# Administrative Action Preliminary Subdivision

**Case File / Name:** S-5-09 / Unity Subdivision

**Nature of Case:** This request is to approve the subdivision of a 6.37 acre tract zoned O&I-1 into 2 lots. Lot 1 is to be 3.55 acres and Lot 2 is to be 2.85 acres in size.

**OFFICIAL ACTION: Approval with conditions**

Proposed Subdivision

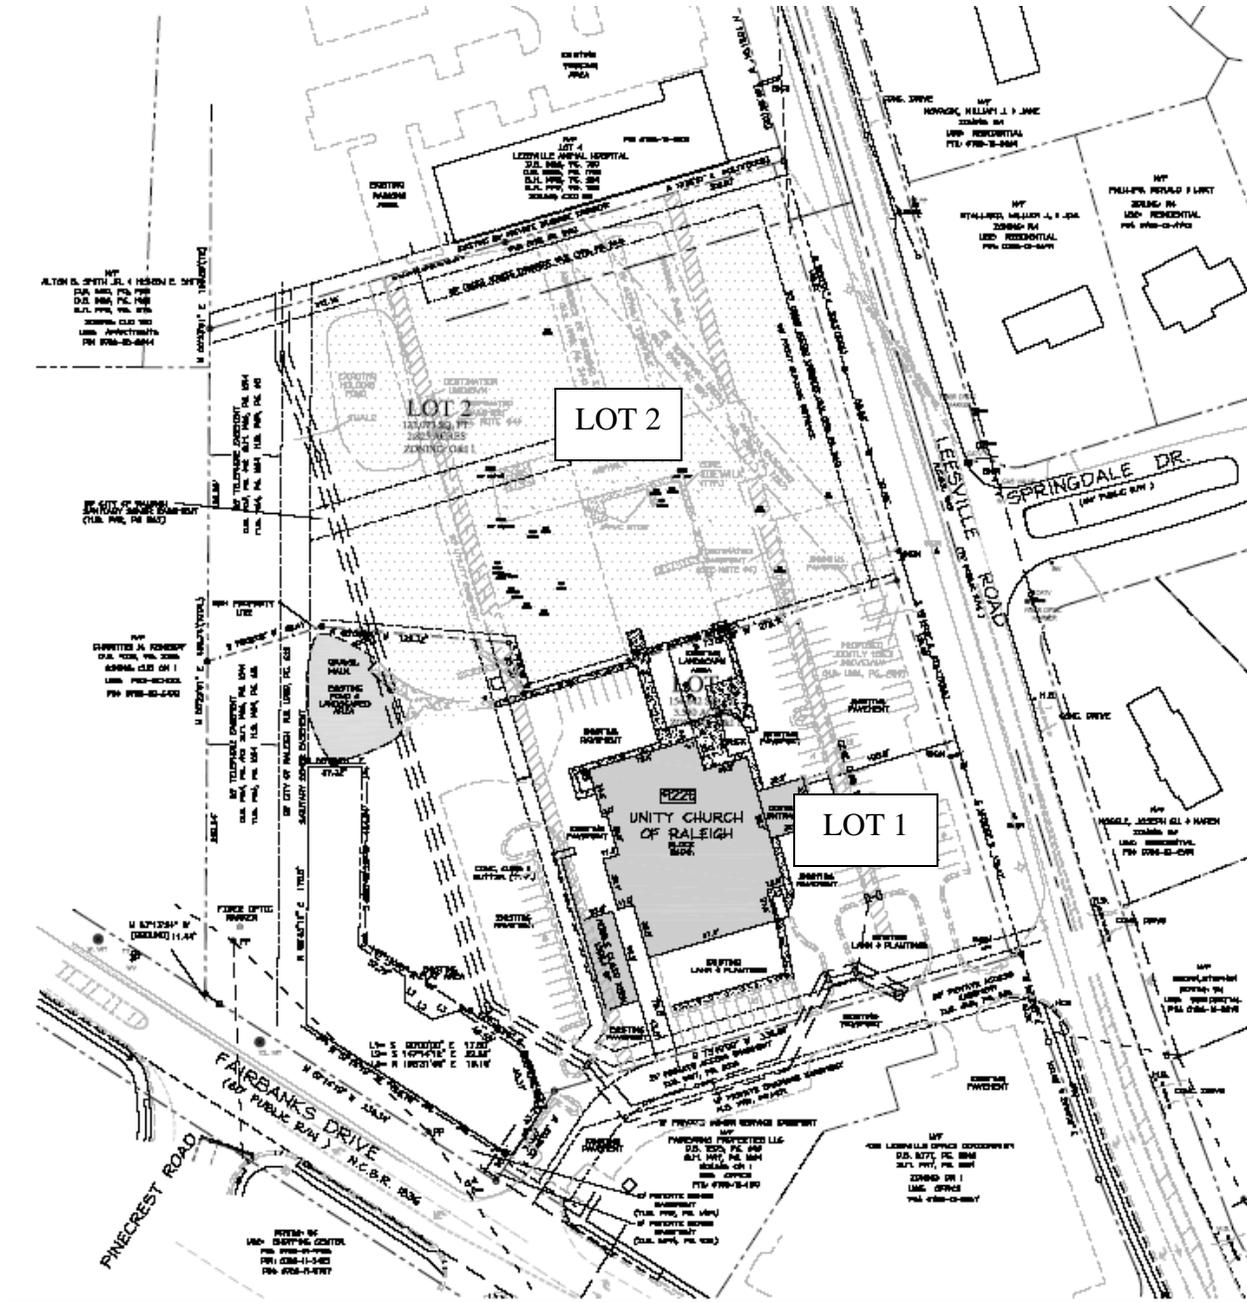
- (1) That prior to the issuance of a grading permit, the final tree conservation plan must be approved by the Forestry Specialist in the Inspections Department. The plan must show metes and bounds descriptions of all tree conservation areas, and tree protection fence around all tree conservation areas. Tree protection fence must be located in the field and inspected by the Inspections Department. A copy of the approved plan is to be placed on file in the Planning Department;

- (2) That construction plans for public improvements be approved by the Public Works Department;
- (3) That approved tree conservation areas be shown on all plats for recording with metes and bounds descriptions in compliance with Code section 10-2082.14;

- (4) That all permanently preserved undisturbed open space used to meet the nitrogen reduction requirements of Part 10 Chapter 9 shall be labeled on recording plats. These plats shall include a note stating: Within permanently preserved undisturbed open space areas used for stormwater treatment, there must not be any land disturbing activity, any placement of impervious surfaces, any tree removal, any new development or expansion thereof, or new use, construction, or encroachment;

- (5) That a 25' permanent slope easement and retaining wall easement along Leesville Road be dedicated to the City of Raleigh as shown on the preliminary plan and be shown on all plats for recording. This easement is eligible for reimbursement at Code established rates;

- (6) That the 25' cross access easement (Book of Maps 1998, page 344) along the Leesville Road frontage only, be abandoned and a new proposed 25' cross access easement deed between Lots 1 and 2 and shared driveway access easement deed opposite Springdale Drive be recorded. These easements are to be general access easements between the two lots with

the final connecting driveway location to be determined at the time of site plan approval on Lot 2. These easement documents are to be recorded and returned to the Planning Department within 14-days of lot recording. If a recorded copy of these documents is not provided to the Planning Department within the 14 day period, further plat recordings and building permit authorization may be withheld;

- (7) That the existing 25' cross access easement between proposed Lot 2 and the northerly adjacent parcel, Lot 4-Leesville Animal Hospital with PIN No. 0788-12-1803 remain as shown in Book of Maps 1998, page 344, and be shown on all plats for recording. This cross access easement does not grant the Lot 4 property access to the shared drive on the south side of proposed Lot 1 (DB 8137 PG 2028) located between Fairbanks Drive and Leesville Road;

- (8) That all sight triangles and sight easements be shown on the recorded map and the following note added: No sight obstructing, or partially obstructing wall, fence, foliage, berm, sign, parked vehicle, or other object between the height of two (2) feet and eight (8) feet above the curb line elevation (or the edge of pavement if no curb exists) shall be placed within a sight triangle. All street trees falling within the sight triangles shown on this plan shall be limbed up between 2 feet and 8 feet in height above the curb line elevation;

- (9) That a fee-in-lieu of construction be paid for widening to a ½ 41' section, curb & gutter and ½-5' sidewalk along the property frontage of Leesville Road, (Lots 1 and 2). This cost will be determined by the Public Works Department based on current fee-in-lieu rates at time of payment;

- (10) That a letter of credit in the amount of 1-1/2 times the cost of construction be provided to the Public Works Department for the required roadway widening on Fairbanks Drive.
